I HEREBY CERTIFY THAT THIS STRUCTURE
WAS BUILT ACCORDING TO PLANS EXCEPT
AS NOTED HEREIN
SIGNED: Stanly DATE 4-1-79

PROJECT No. 6.804135
STANLY-MONTGOMERY COUNTY
STATION 58+67.0-L
SHEET 1 OF 2
STATE OF NORTH CAROLINA
STATE HIGHWAY COMMISSION
RALEIGH
GENERAL DRAWING
BRIDGE OVER PEE DEE RIVER
ON NC 24/27
BETWEEN ADERVAARLE AND TROY

GENERAL DRAWING
BRIDGE OVER PEE DEE RIVER
ON NC 24/27
BETWEEN ABERNATHY AND TOLSON

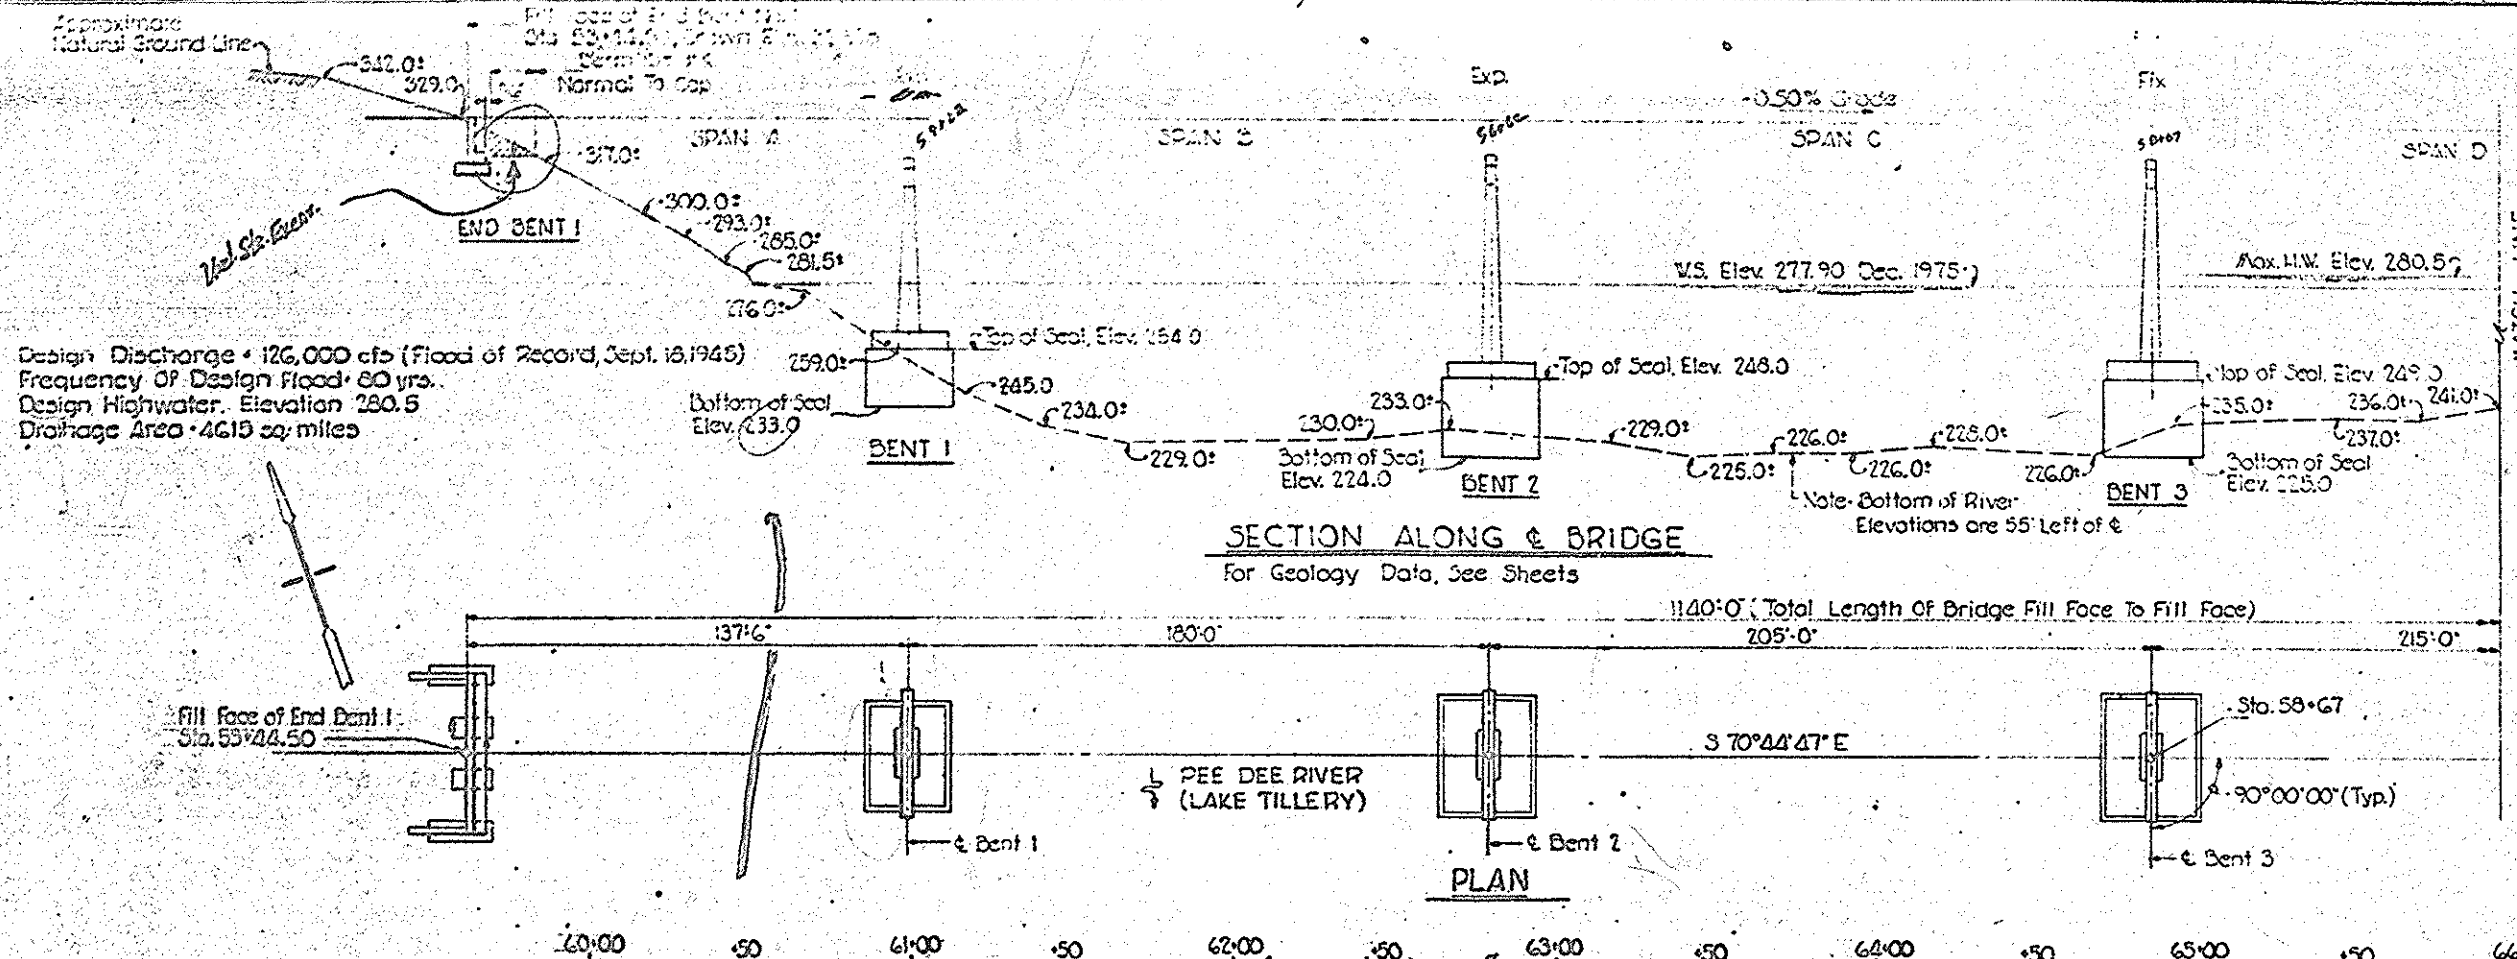
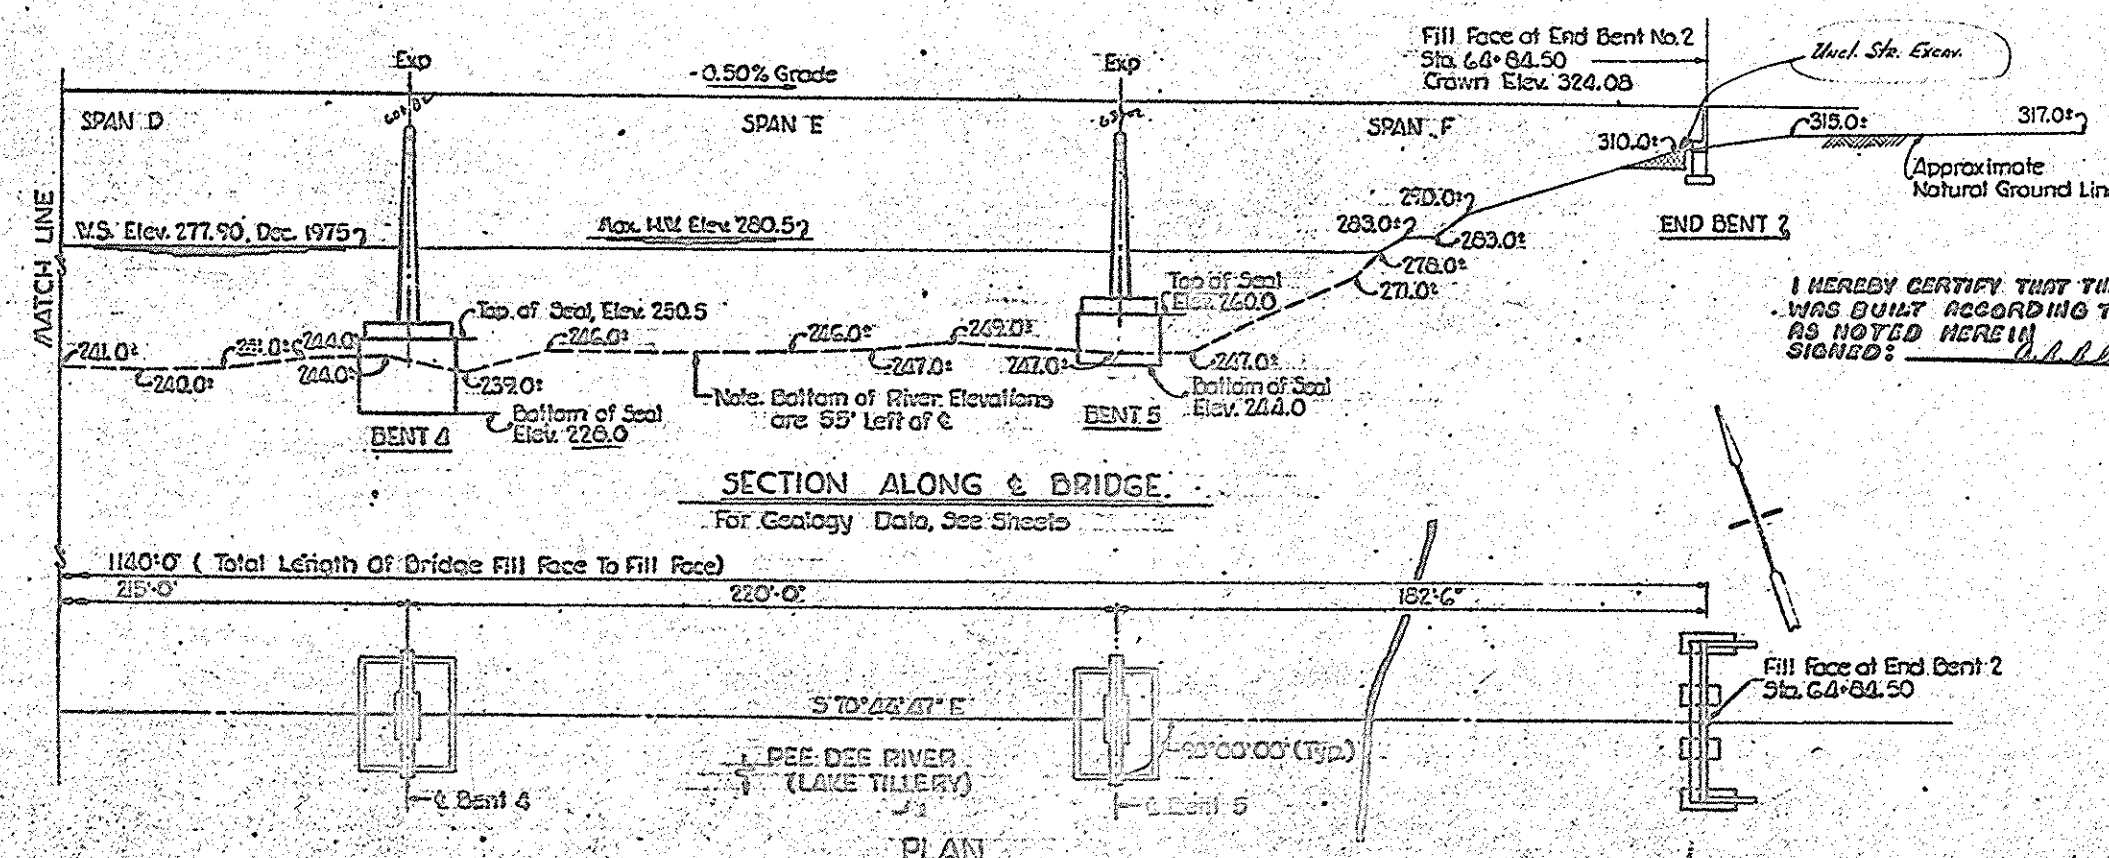
Rev 21-Desired To Change Top of Seal Elev. For Bent #1 By G.L. & E.M.D.

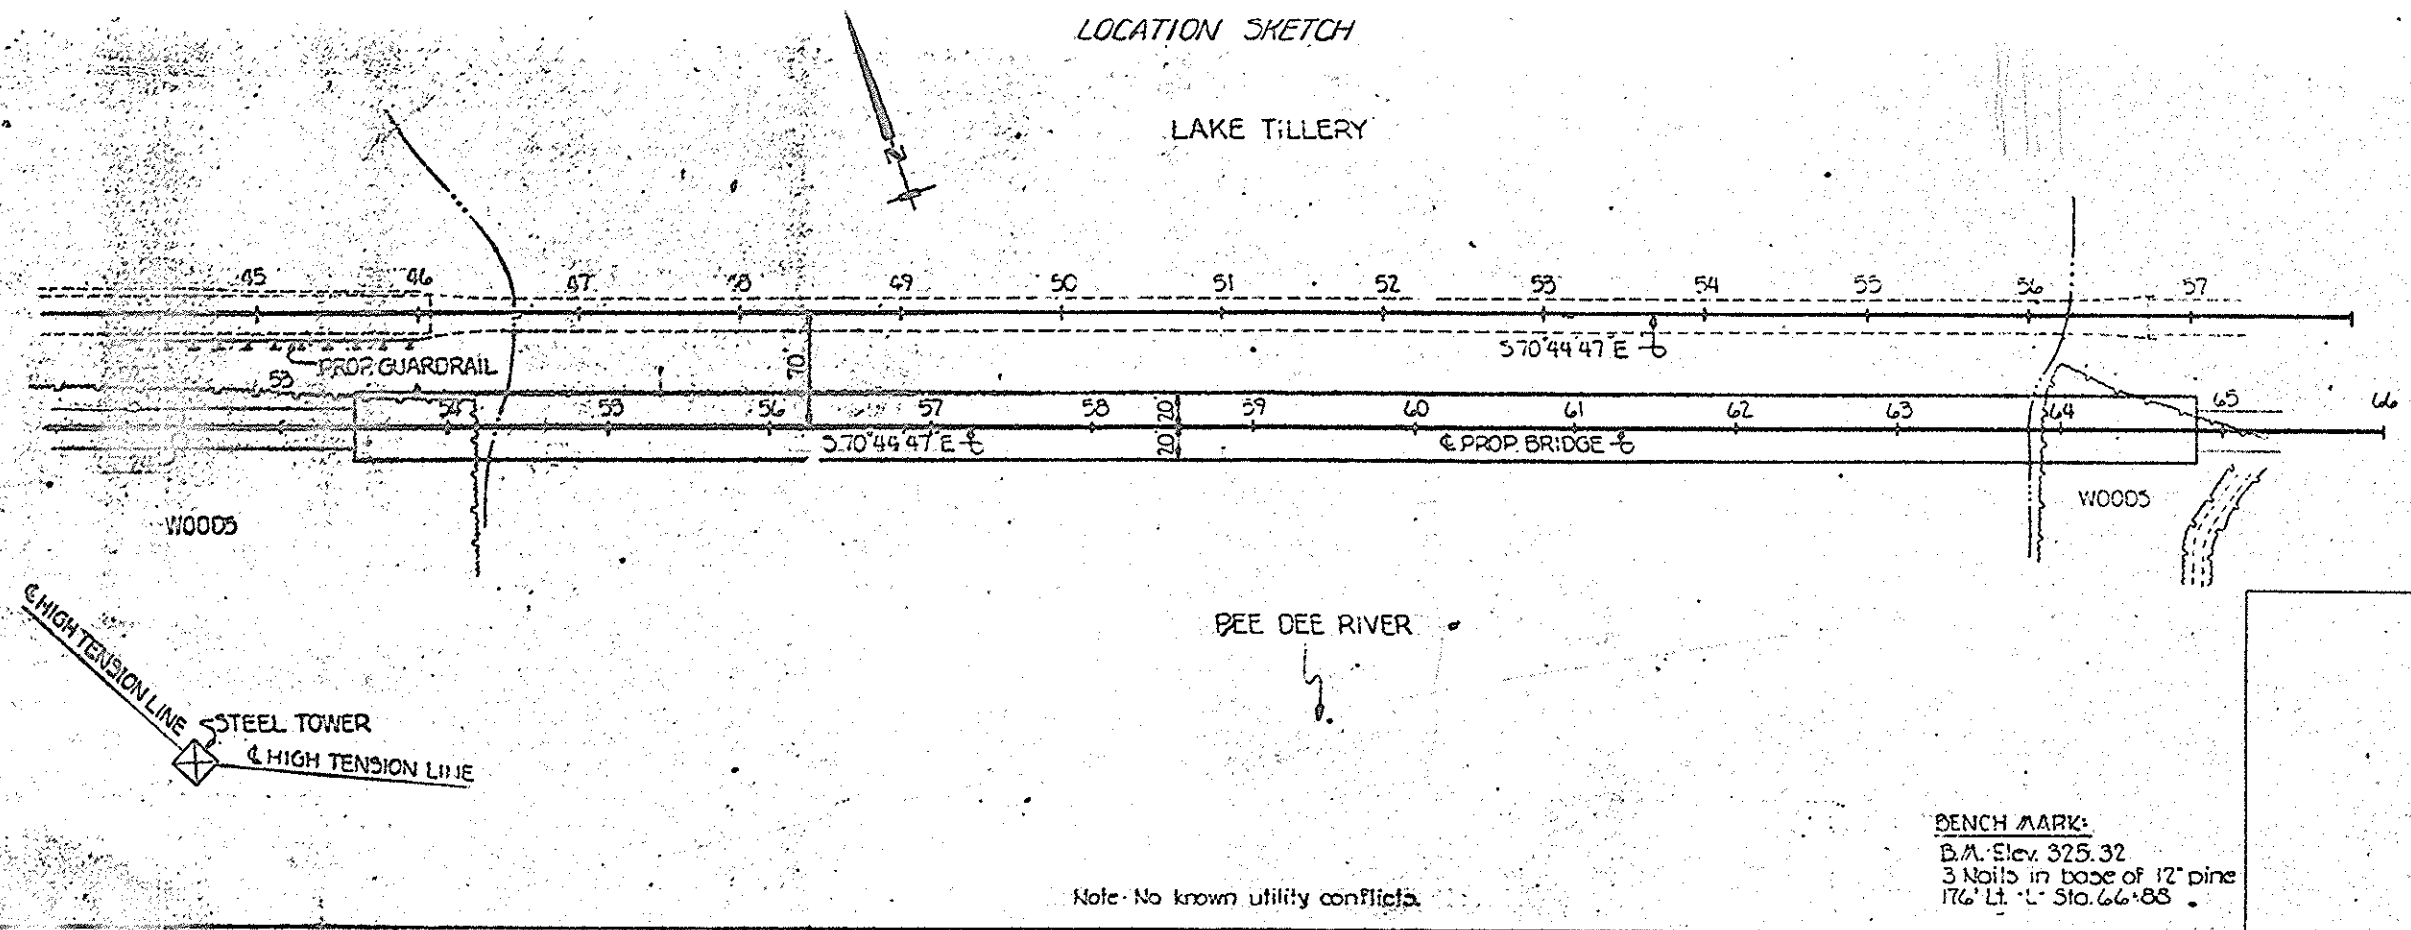
Δ Error in Plan Quantity; Confirmed by Structure Design Unit; See B.G. Jenkins' letter dated 4-22-00 to D.B. Roberts. gkr

* See Sta. Pay Record Book #1, page 672 for explanation of this change. gkr

* Note: See General Notes in Sta. Pay Record Book #1 for explanation of changes in Class "A" Concrete, Class "AA" Concrete, & Linseed Oil. gkr

Rev. #2 - Revised To Change Total Bill Of Material Quantities For Bent #1 & Bent #2 By G.L. By E.W.A.
Rev. #1 - Revised to accommodate Exp. Sta. Seal as submitted by the contractor. By J.C.C. By A.R.S.

STATE OF NORTH
CAROLINA
SUPERSTRUC
TURAL DIVISION
TYPICAL SECTIONS
L.H.S. 20-44, C
5 STEEL GIRDERS, 6 SP
BARRIER RAIL, S
A-58B UNPAINTED

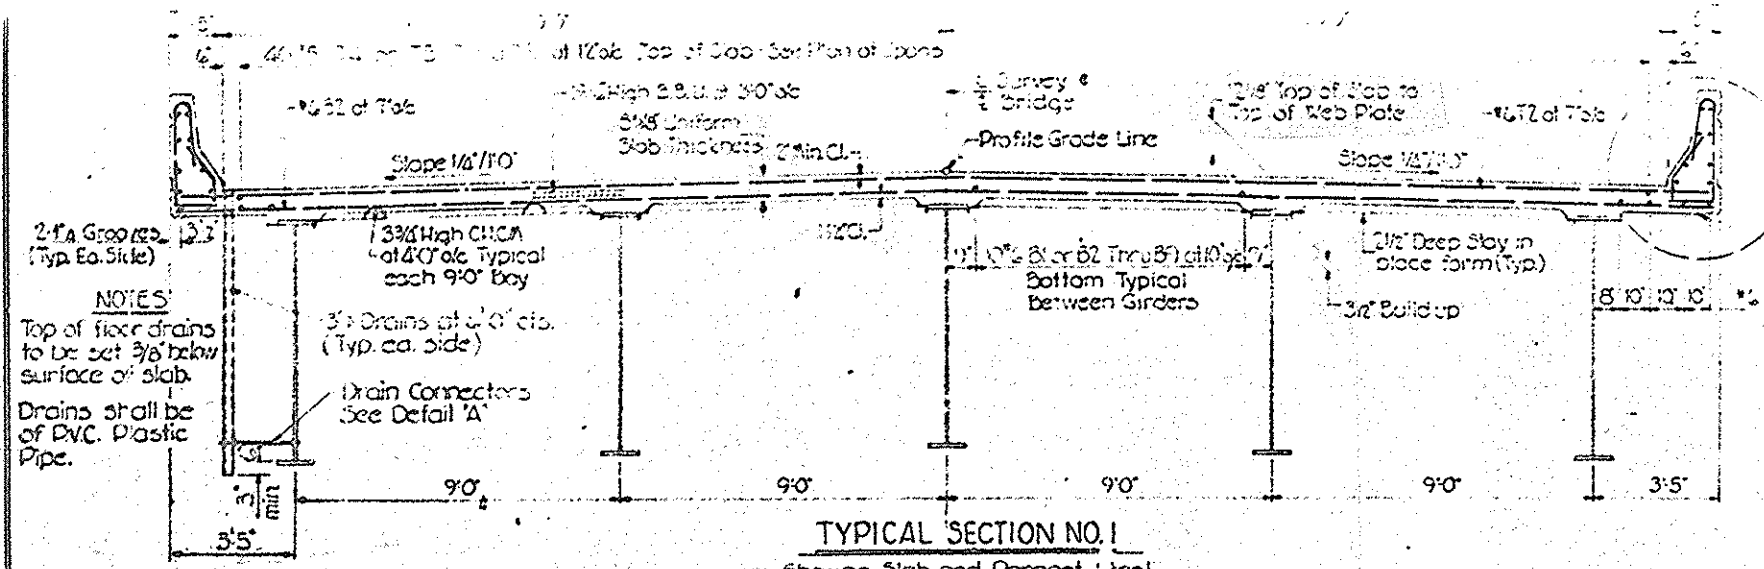
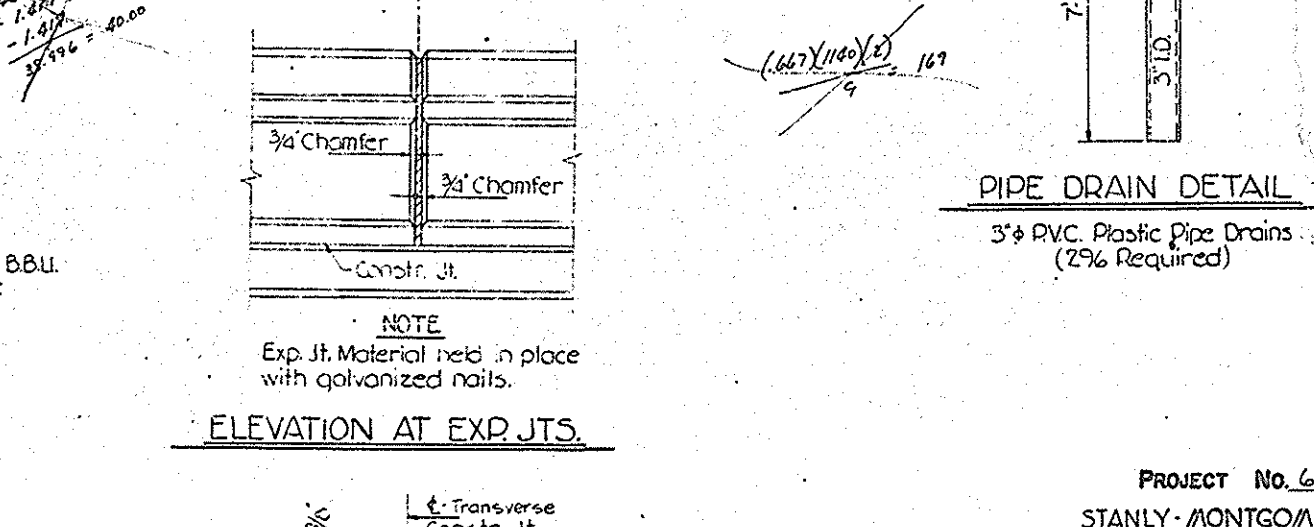
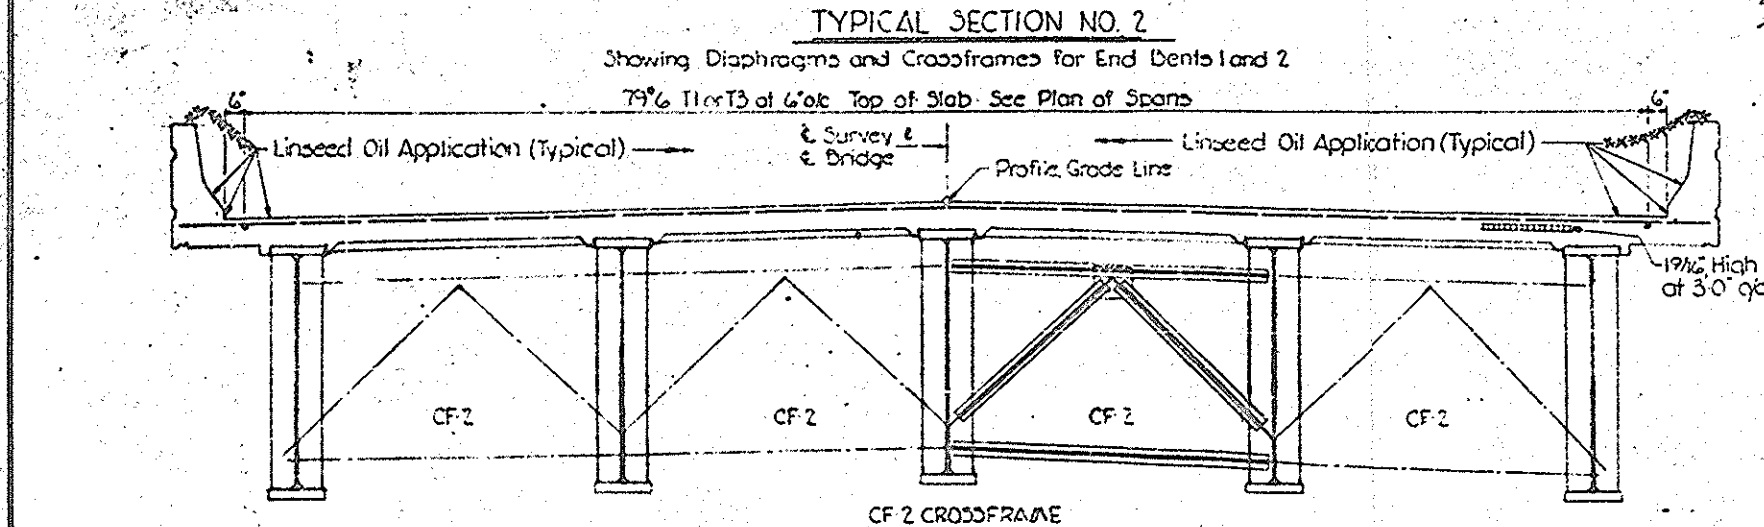
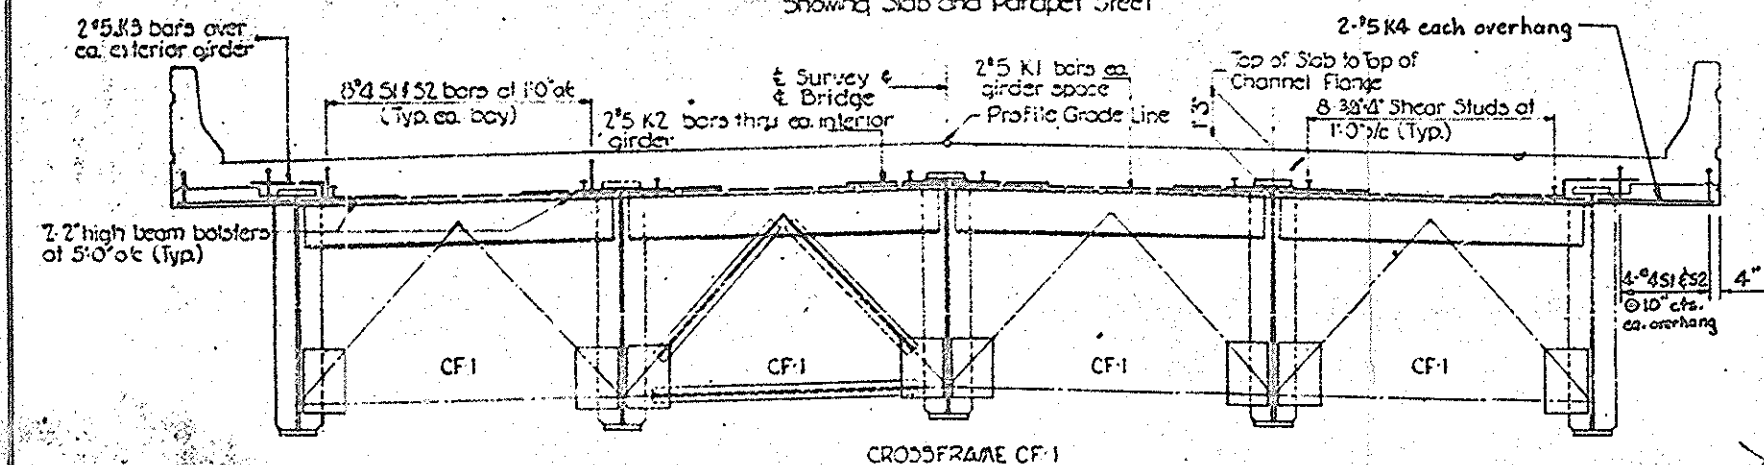
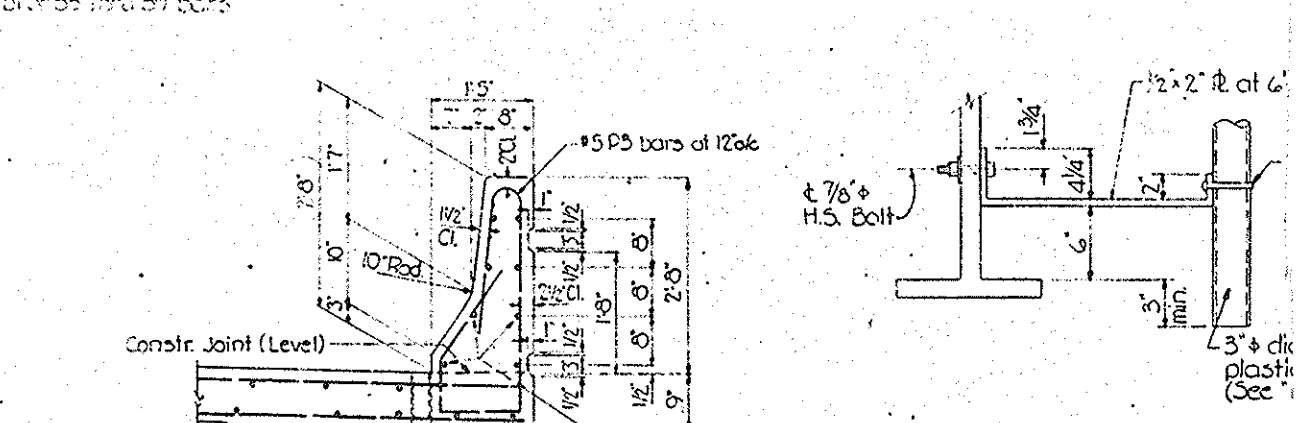
NOTE: LINSEED OIL WAS NOT APPLIED TO TOP OF BARRIER RAIL AS SHOWN ON THE RAIL. ITS DISPOSED BY THE CONTRACTOR.
B.F. STICKLAND
